PREPARED FOR THE URBAN DESIGN COMMISSION AND PLAN COMMISSION

Project Address: 126 South Carroll Street
Application Type: Rezoning
Legistar File ID # [37800](#)
Prepared By: Heather Stouder, AICP, Planning Division
Report Includes Comments from other City Agencies, as noted

Requested Action: Approval of a rezoning from PD-SIP to Amended PD-SIP for the construction of a nine-story mixed-use building with 5,900 square feet of commercial space and 88 residential units.

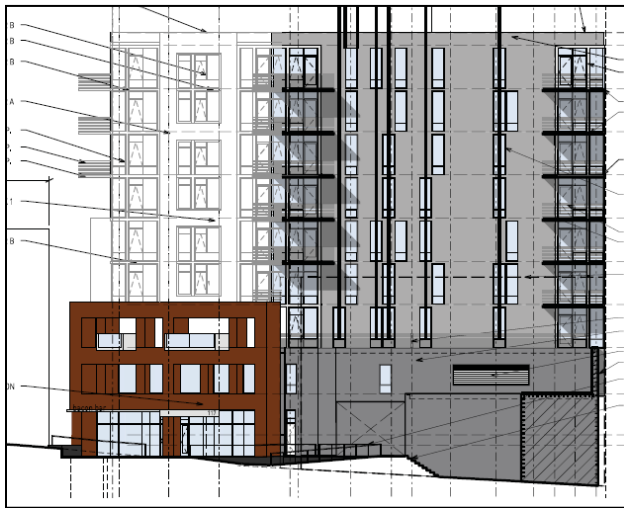
However, the proximity of the proposed building to these property lines corresponds with a building code limitation for the percentage of window openings on these two facades. In a revised version of the plans (submitted and reviewed by the Landmarks Commission), the design is much more compatible with the other facades on the building, and staff appreciates the significant improvement over the originally submitted elevations (see comparison below).

Due to the proximity of the facades to the respective property lines, many of the window panels on these two facades are false - opaque spandrel glass in front of walls and columns. The UDC should pay special attention to the detail for the proposed spandrel to ensure that it will read as a window, particularly from the long views toward these facades from both the Capitol Building and from the bottom of the hill on South Hamilton Street.

Corner of Doty and Carroll Streets

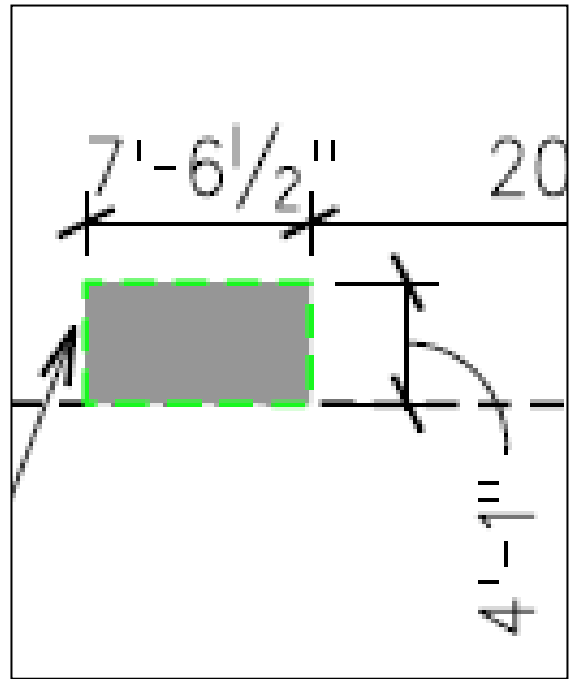
As mentioned on page 3 of this report, the applicant is requesting approval for an encroachment into South Carroll Street for balconies associated with dwelling units at the corner of West Doty and South Carroll Street (see rendering and encroachment exhibit below). As mentioned in Condition No. 25, the request must be approved separately as a privilege in streets agreement, and may not be approved as part of this request. As with the similar balconies shown on other sides of the building, staff would prefer that the balconies be placed on private property, within an inset of the building.

Beyond the encroachment issue alone, staff would like for the UDC to carefully review the similar balconies shown on the building exterior on other sides of the building. Staff believes that these could be improved if adjustments were made to inset, or at least partially inset the balconies.

25. The Applicant shall obtain a privilege in streets agreement for any encroachments inside the public right of way. The approval of this development does not constitute or guarantee approval of the encroachments (INFORMATIONAL).
